UNITED STATES PATENT AND TRADEMARK OFFICE

APPLICATION NO.	FILING DATE	FIRST NAMED INVENTOR	ATTORNEY DOCKET NO.	CONFIRMATION NO.
10/813,928	03/31/2004	Admir James Mesalic	MES1.002	5800
39863	7590	05/18/2006	EXAMINER	
SONNABENDLAW 600 PROSPECT AVE BROOKLYN, NY 11215			EDEL, JOSEPH F	
			ART UNIT	PAPER NUMBER
			3636	
DATE MAILED: 05/18/2006

Office Action Summary	Application No. 10/813,928	Applicant(s) MESALIC ET AL.	
	Examiner Joseph F. Edell	Art Unit 3636

DETAILED ACTION

Diagram A - Annotated Figure 1 of Hannigan

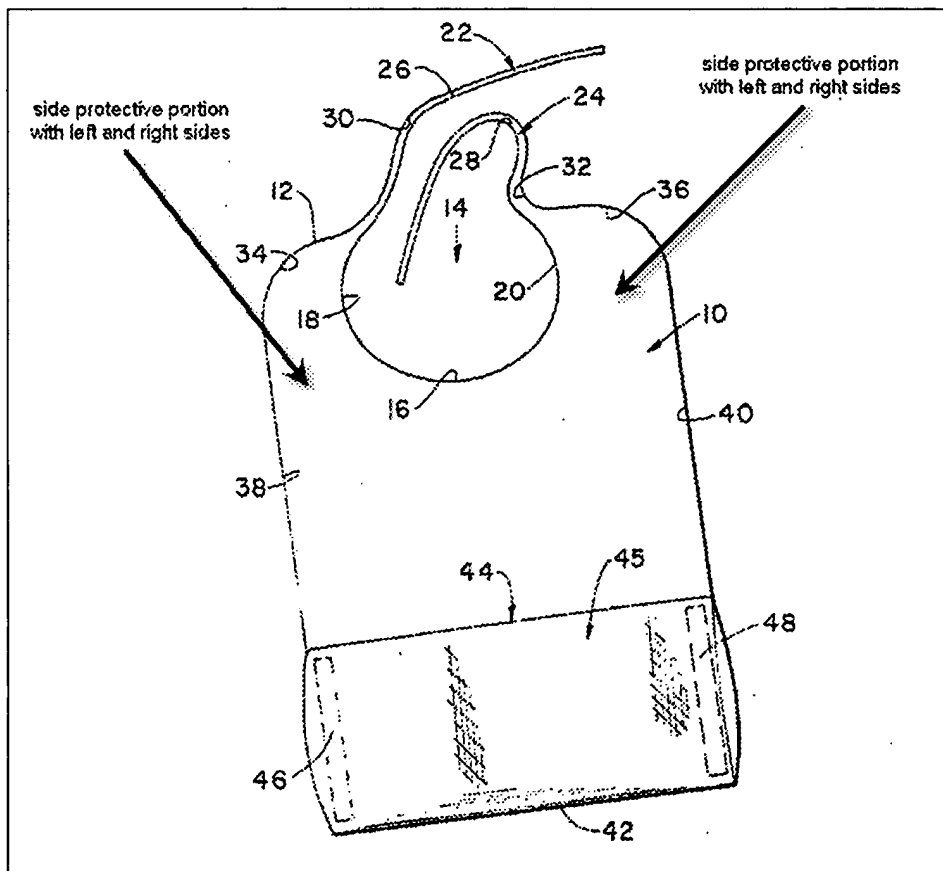
Hannigan discloses a protective covering that includes all the limitations recited in claims 6-12, 35, 39, and 41. Hannigan shows a protective covering having a main protective portion/main placemat area (See Fig. 2), a front protective portion/at least one side flap (see Fig. 1) attached to the main protective portion, two side protective portions/side flaps (see Diagram A below) with left and right sides and orthogonal to the front protective portion, and a coupling element 22,24 of the side protective portions that is ribbon ties, and a bottom side of the main protective portion including skid resistant portions 46,48 wherein the front protective portion is capable of attaching to a front arm

portion of a child's chair and to extend from a table top to the child's chair, the main protective portion including a pocket 44 (Fig. 1) formed therein.

With respect to claim 10, the drawings remain objected to under 37 CFR 1.83(a) because the claimed skid resistant portions are not shown in the drawings. Applicant argues that the tape straps do not meet the limitation of claim 10 because the straps are used to form the pocket 44. However, the pocket is an optional feature of the covering disclosed by Hannigan. Claim 10 recites that the bottom side of the main protective portion includes skid resistant portions. When the tap straps of Hannigan are not being utilized in forming the pocket, the tape straps meet the limitation of the skid resistant portions of claim 10 because the tap straps would resist skidding of the protective covering when laid upon a surface.
